Our ref: SL/2012/109845/01-L01
Your ref: 12/0969/SD
Date: 6 July 2012

Submission of details pursuant to part discharge condition 35 (Tree Root Containment) in regards to Blocks 2, 8 and 9 and discharge condition 43 (Lifetime Homes Standard - Wheelchair Access) in regards to Blocks 2 and 3 of planning permission dated the 30/03/2012 (ref: 11/2959/V) and discharge Clause 9.1.2 (Use of River Thames) in regards to Blocks 2, 8 and 9 of legal agreement dated 30/03/2012 (ref: 11/2959/V).

Lovell's, Granite, Baldcock's and Pipers Wharves, Pelton Road, Banning Street/Christchurch Way, Greenwich, SE10

Figure 14: Section A-A'

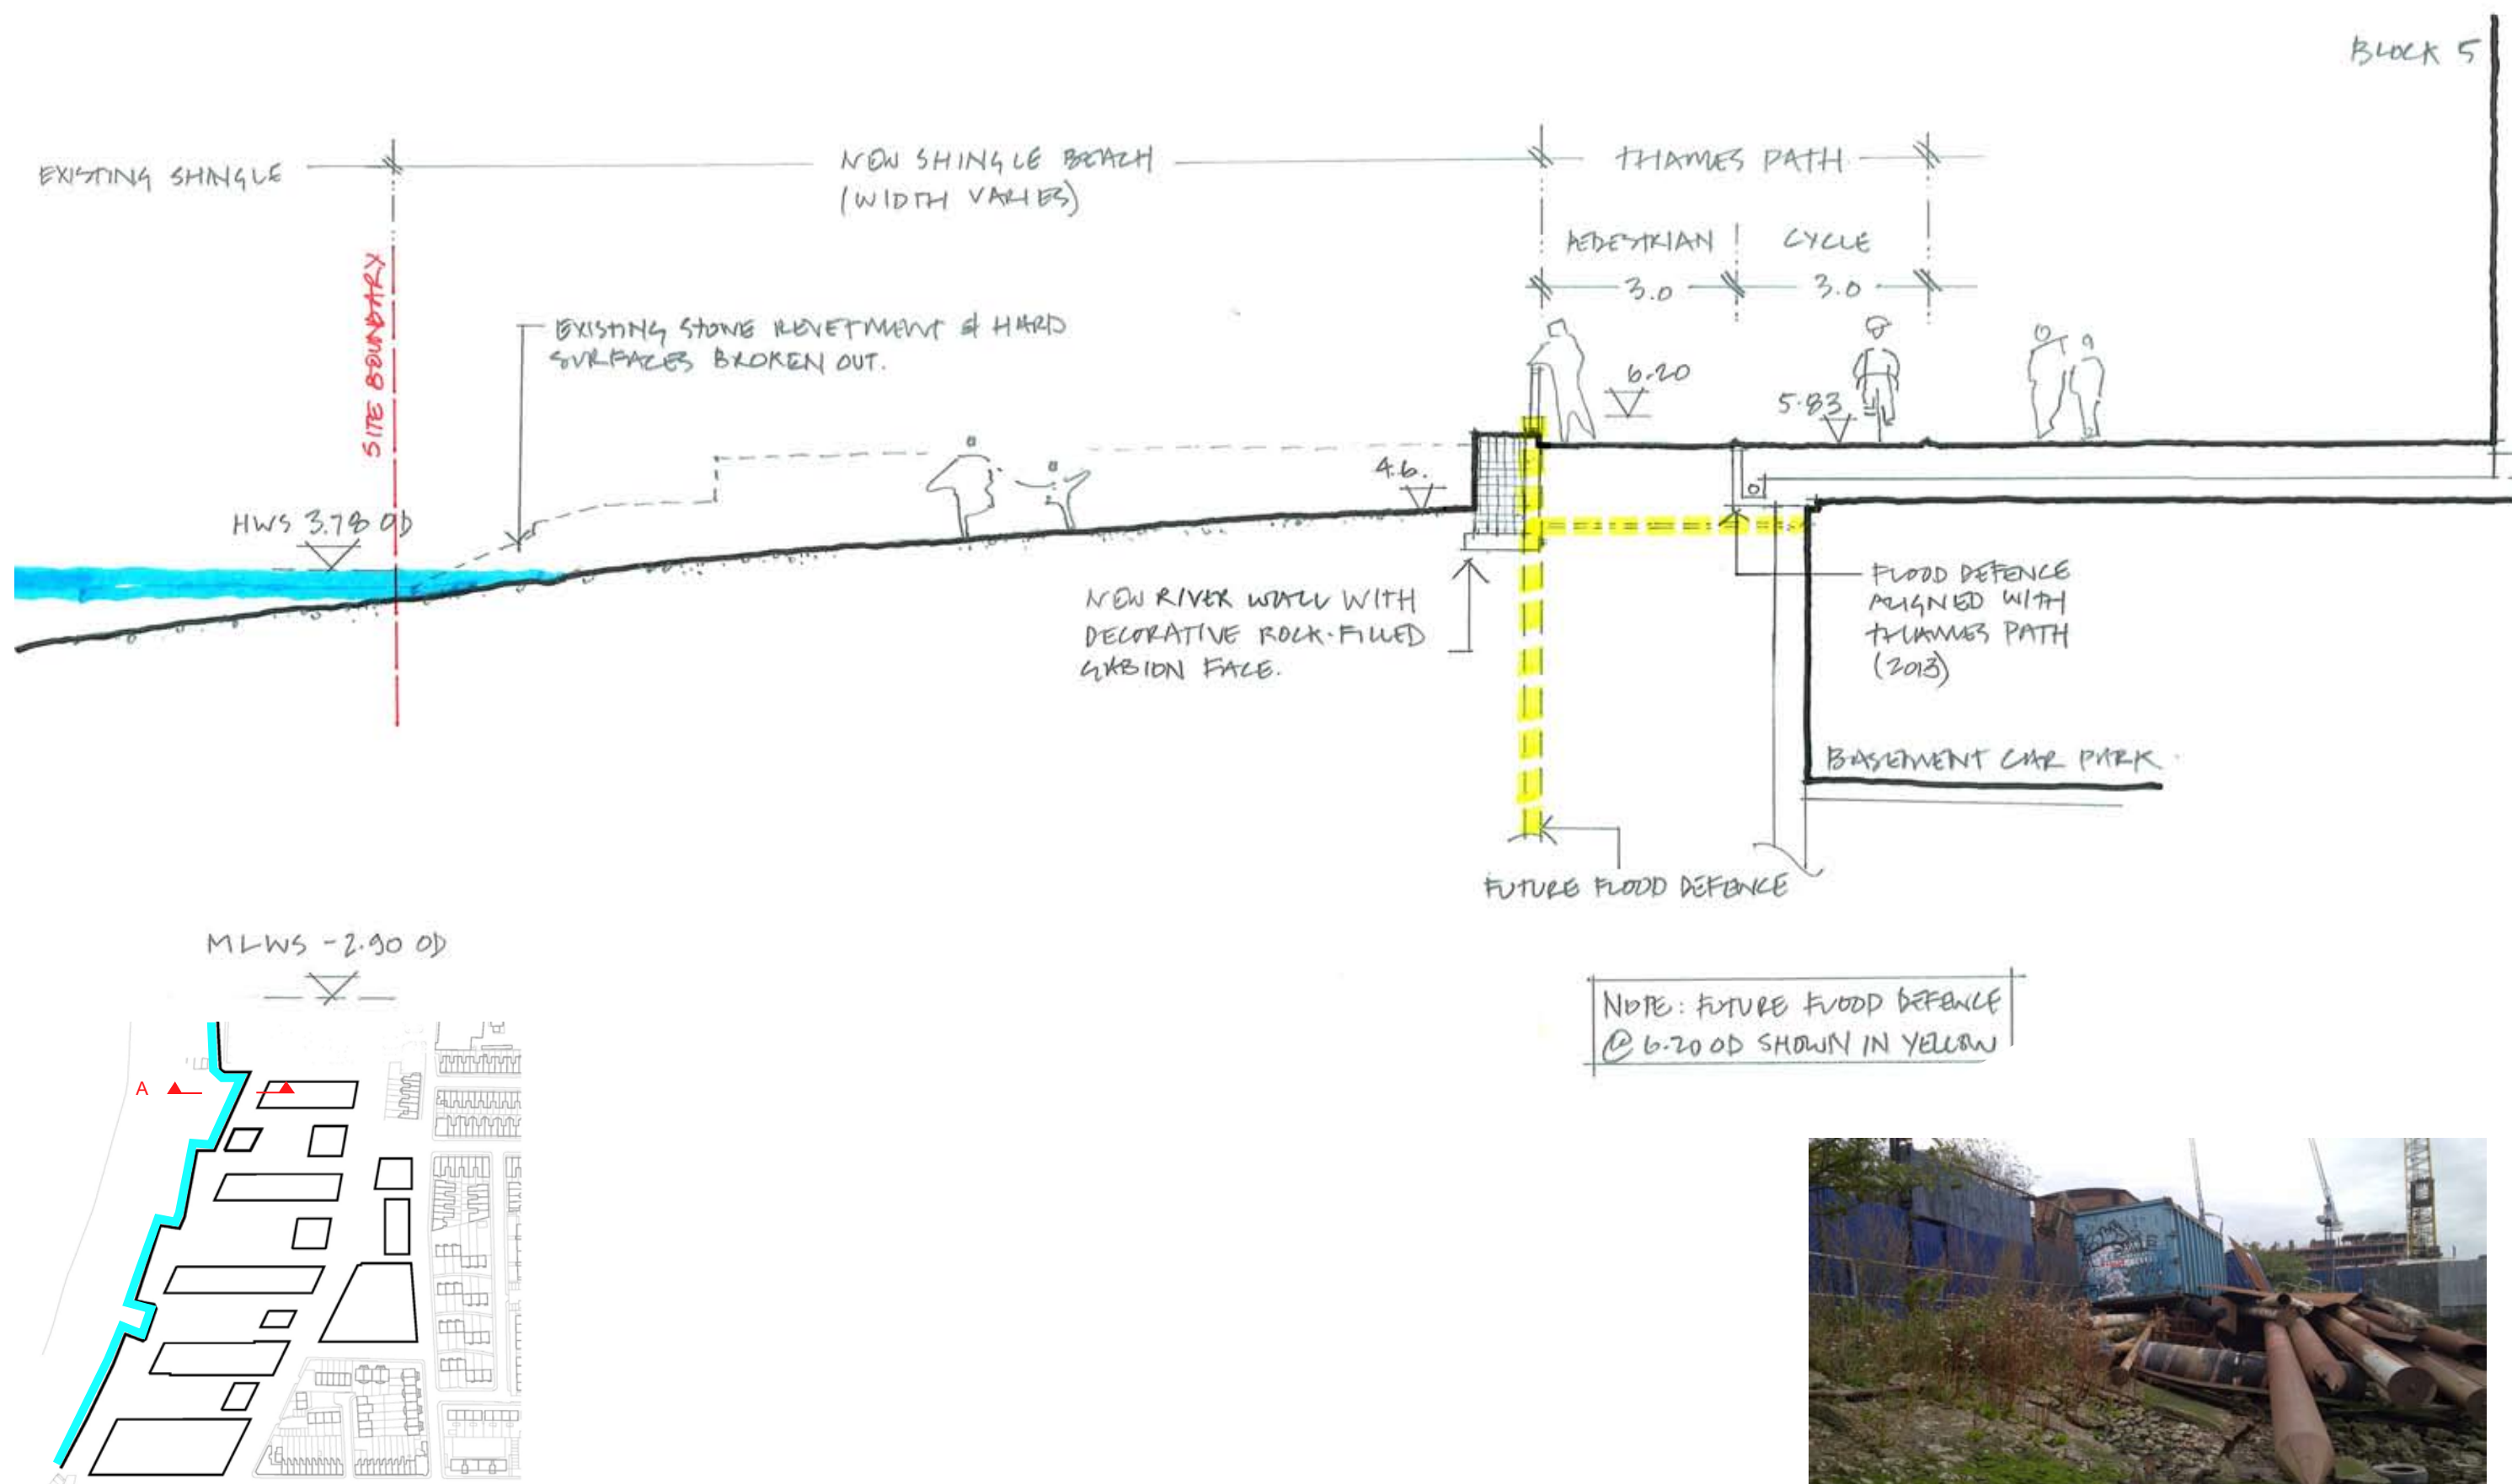
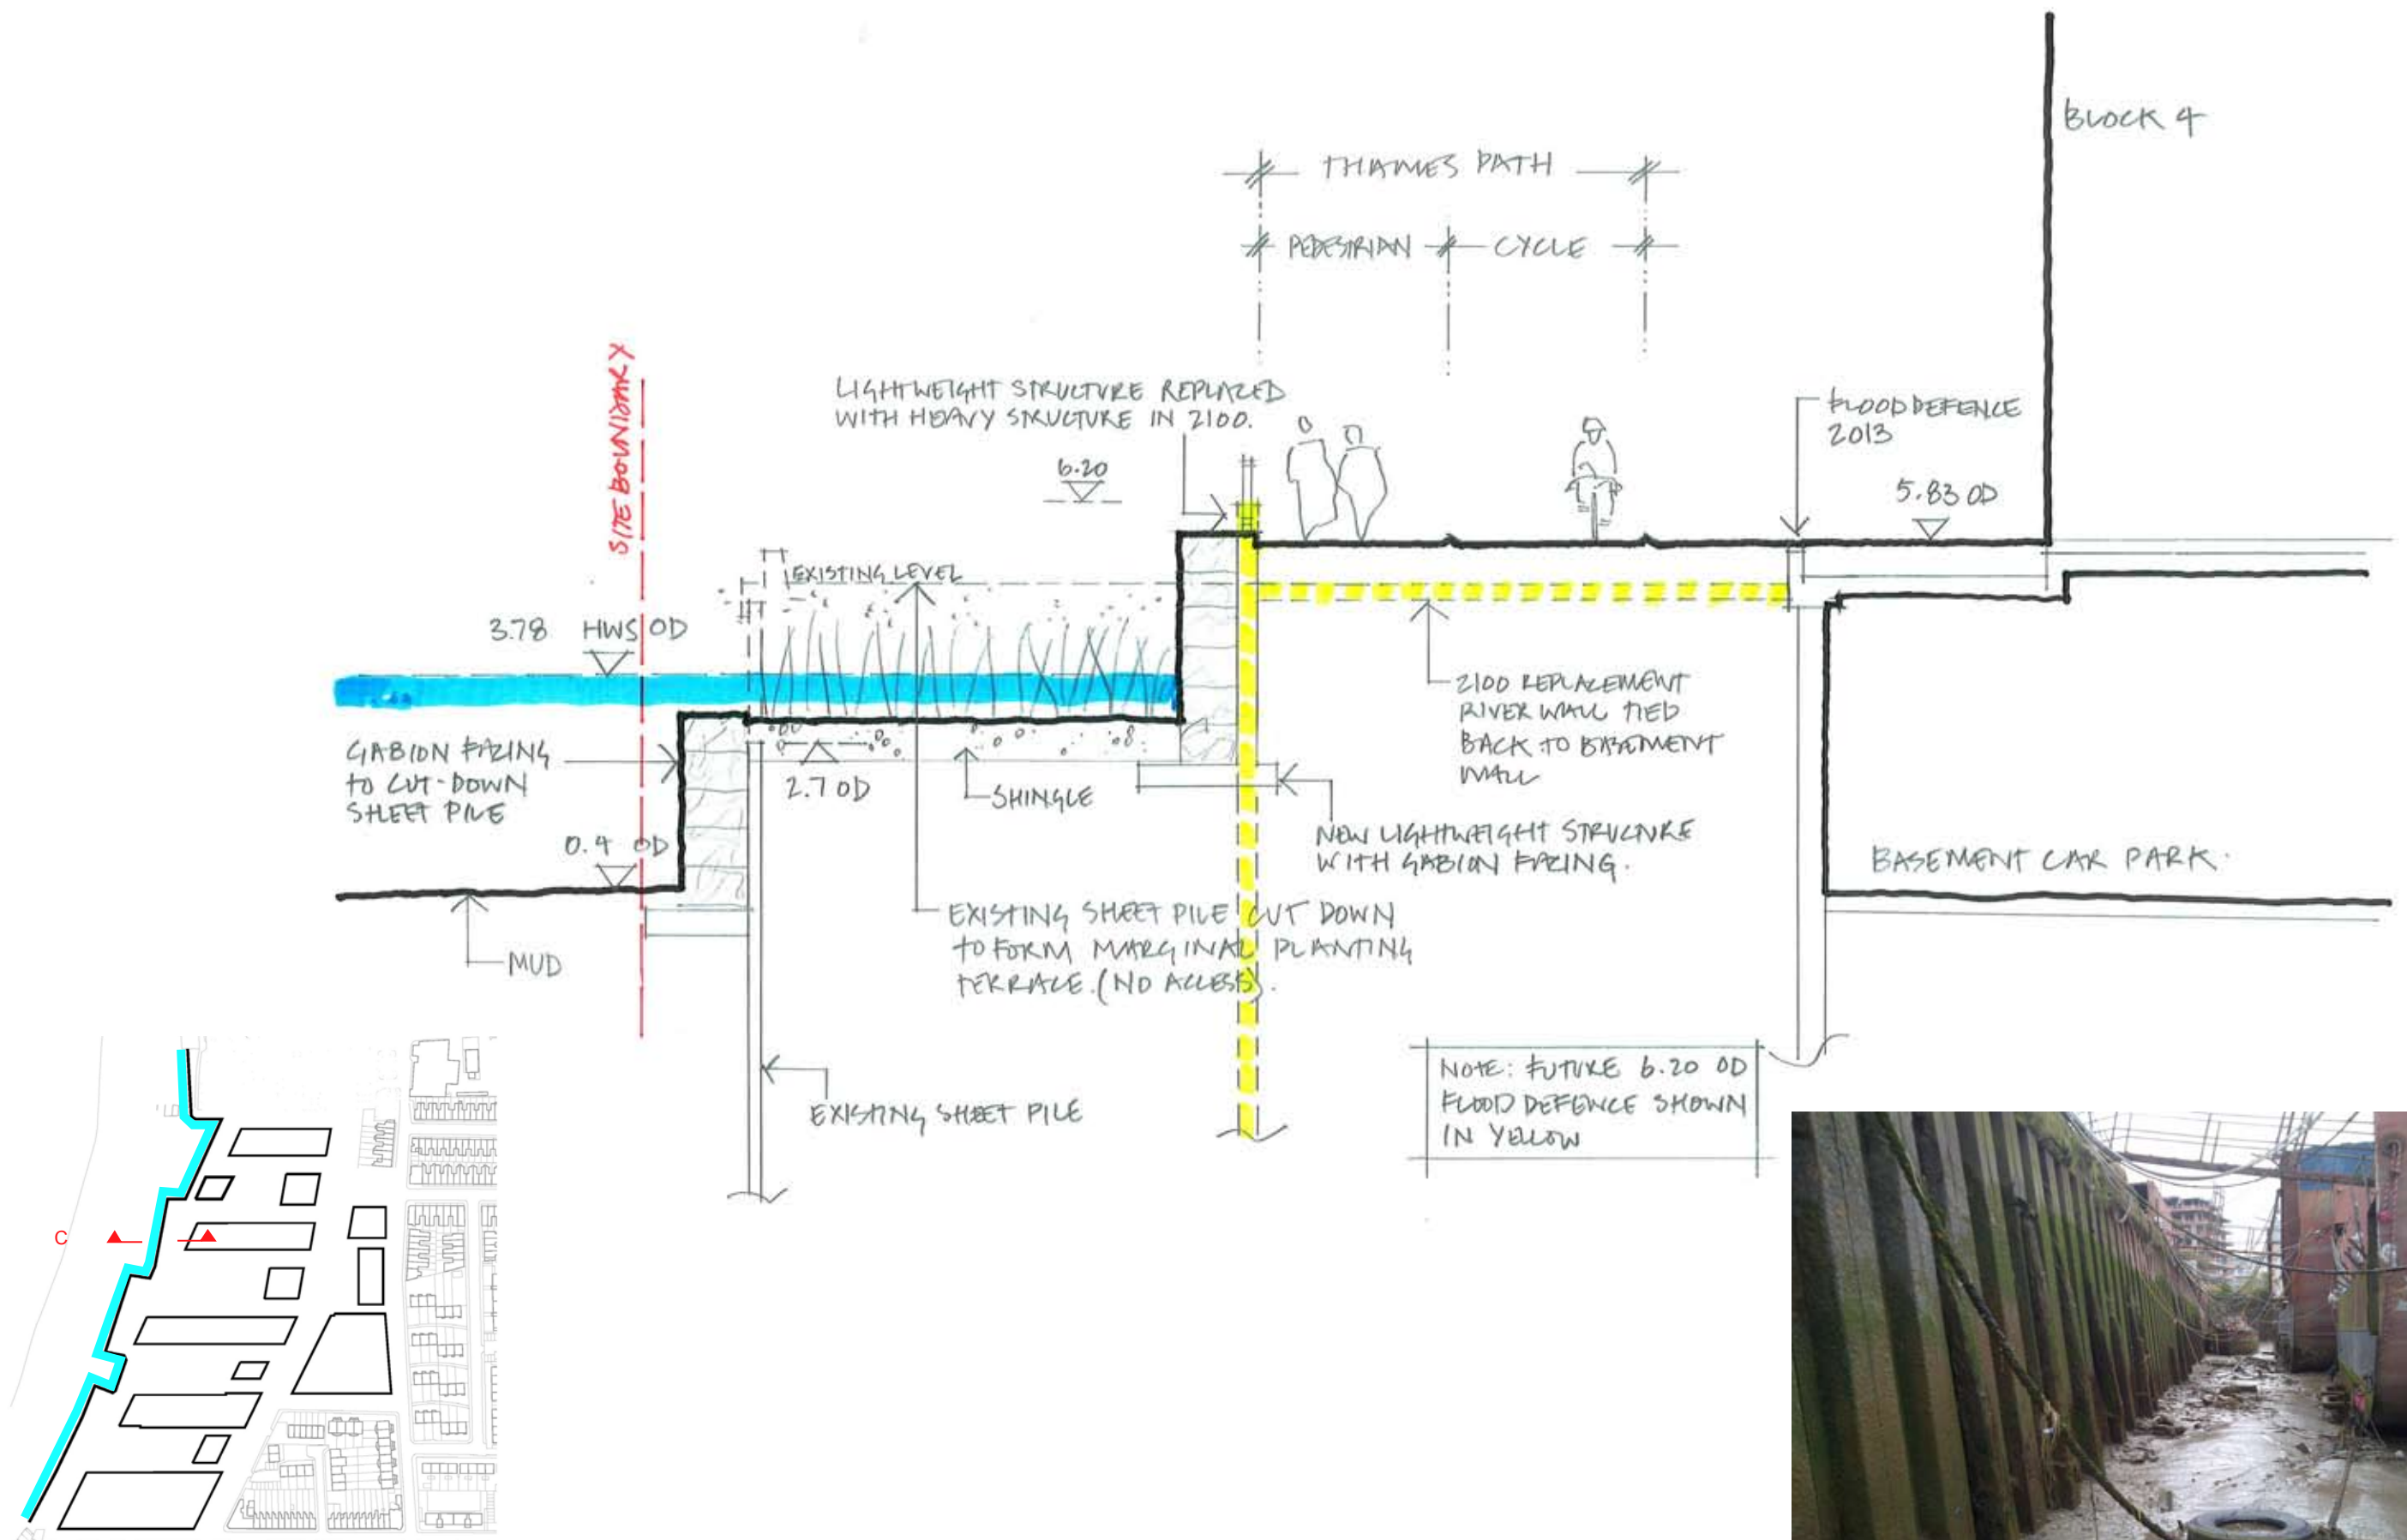
Sections 14 and 13 indicate that the back of the flood defence wall will form the upstand of the riverward side of the planter. The flexible root barrier along this edge is unlikely to offer adequate protection to the flood defence from root penetration.

To ensure that the risk of root penetration to the flood defences is minimal we ask that the applicant consider one or more of the following options:

- off set of the tree planting from the back of the flood defence;
- an alternative form of root barrier; or
- a specific tree planting schedule.

We would not wish to see any trees within 5 metres of the river wall.

We would prefer the riverside to be planted in separate areas with individual root containment.
